Revision: 1	Customer Service + Mod	Page Size: A4	keith@snook.eu
Beard P35 Modified - RH channel			
20 Sept 2012	Drawn: K. Snook	Checked:	Page 1 of 1

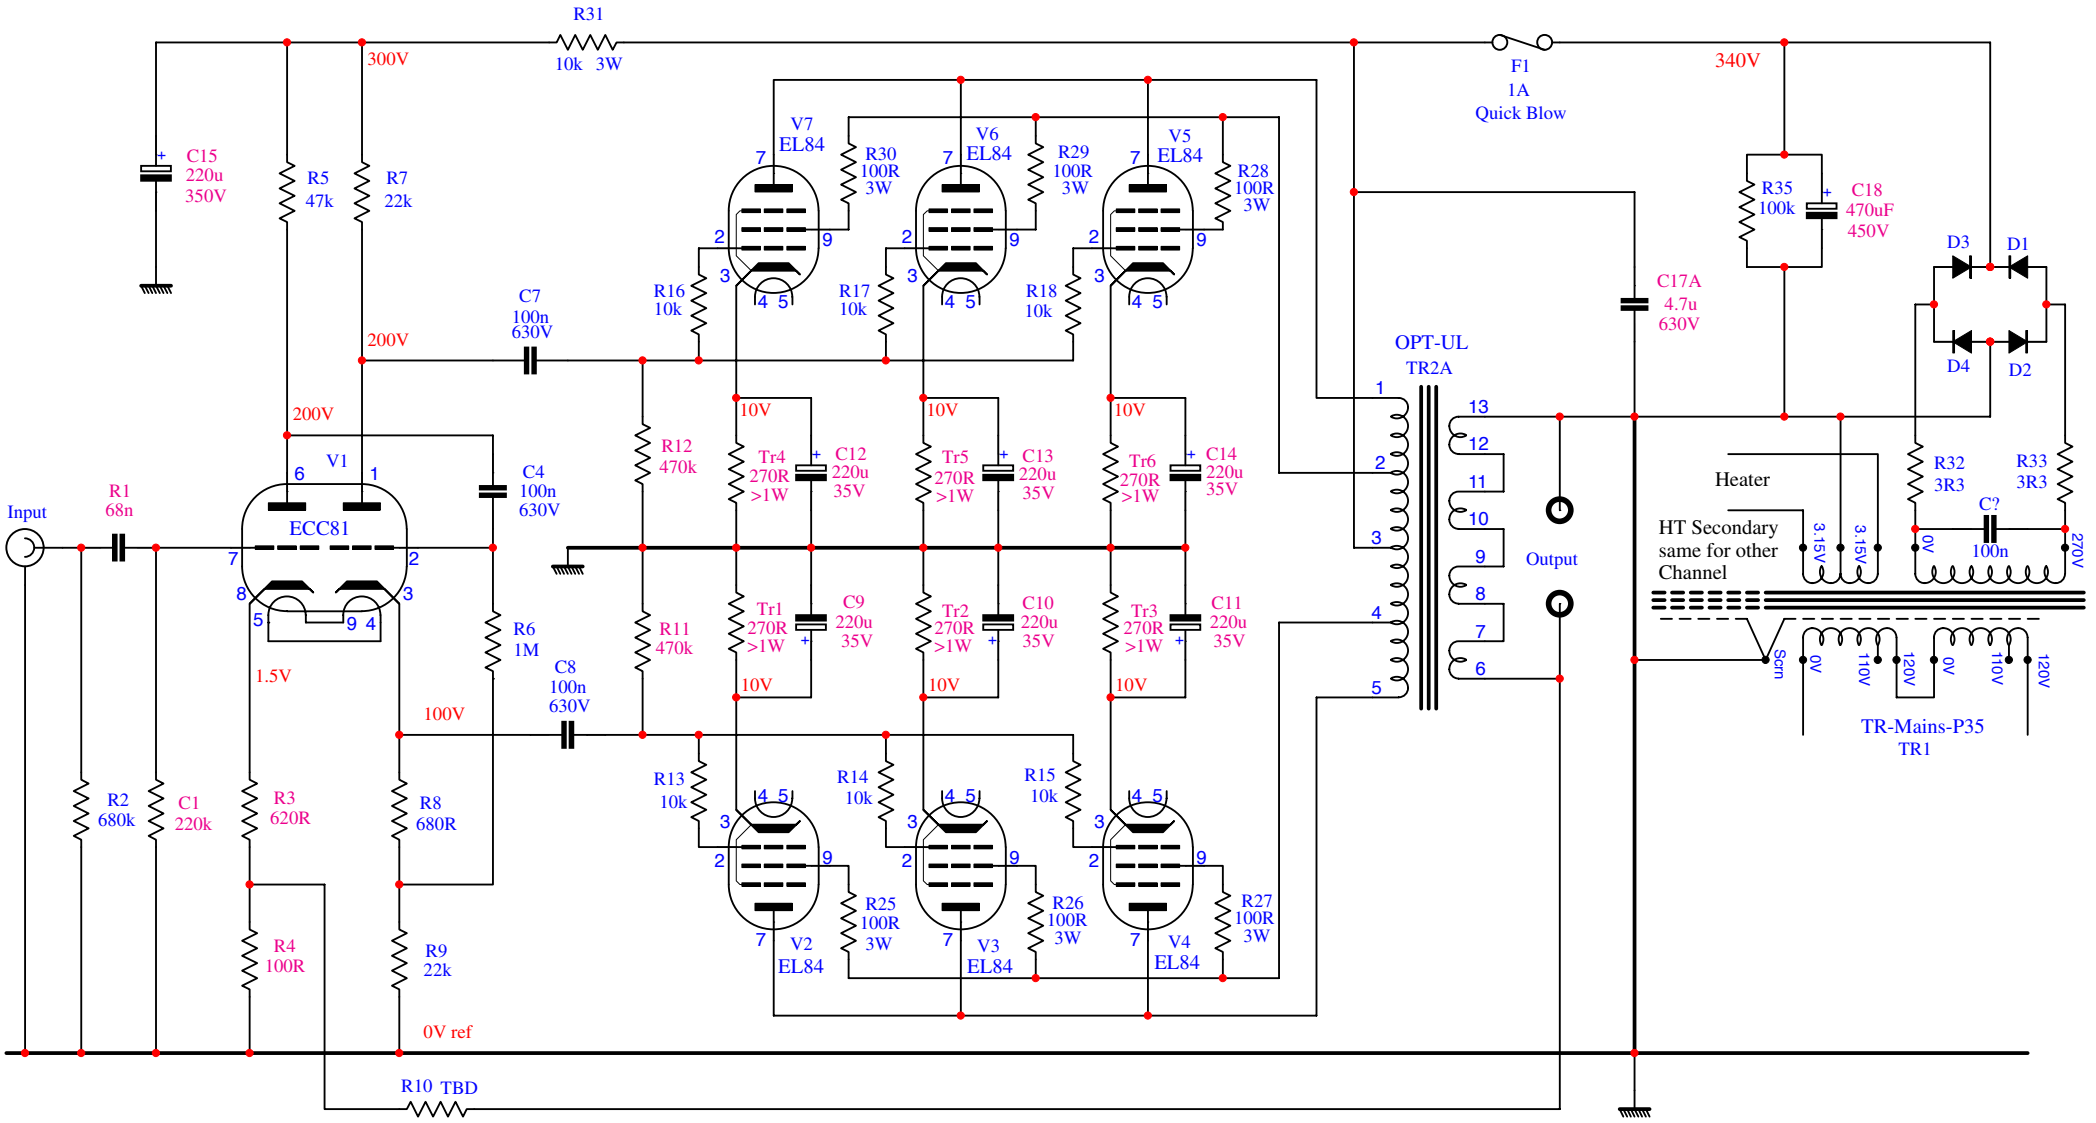
1) Resistors without power rating value are MRS25 0.6W
2) Derived from scrappy hand drawn schematic SOLD by Beard Audio which did not match actual build or have reference designators
3) LH Channel similar to RH with reference designators +100 except possitions R5 and R7 which may both be marked R107?
4) V101 LH Channel has the triode section pins swapped 123 = 678 and vice versa and V105-V106-V107 = V7-V6-V5
5) New output transformers were wound by UK manufacturer and enabled removal of C3 and C5 with better overall performance
6) Input stage beocmes a.c. coupled – R1 position is now a Capacitor and C1 a resistor for d.c. path of V1 - V101
7) Voltages shown in red are approximate and measured with high impedance meter – Some component changes marked in magenta
